Subject:
 RE: SES-MOD-20201218-01417; Call Sign:E080229

My name is Andy Rzeszut and I'm an engineer with TelAlaska, Inc. here in Anchorage, Alaska. I'm the engineer that prepared the filing associated with the modifications to FCC callsign E080229.

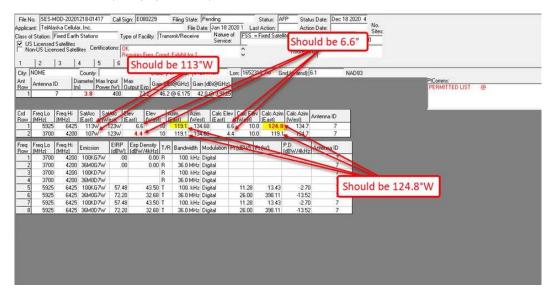
Azim on 5925-6425 will be changed to 124.8.

Please confirm this for me.

Yes, the CalcAzim (East) for both the 5925-6425 MHz and 3700-4200 MHz frequency ranges should be 124.8°W. Additionally, the SatArc (East) for both frequency ranges should be 113°W (not 107°W) and the CalcElev (East) for both frequency ranges should be 6.6°.

With the above values for SatArc (East), Elev (East)/CalcElev (East), and Azim (East)/CalcAzim (East) agree with the information included in the Frequency Coordination Report for the Nome earth station.

See the annotated screenshot below (based upon your screenshot).
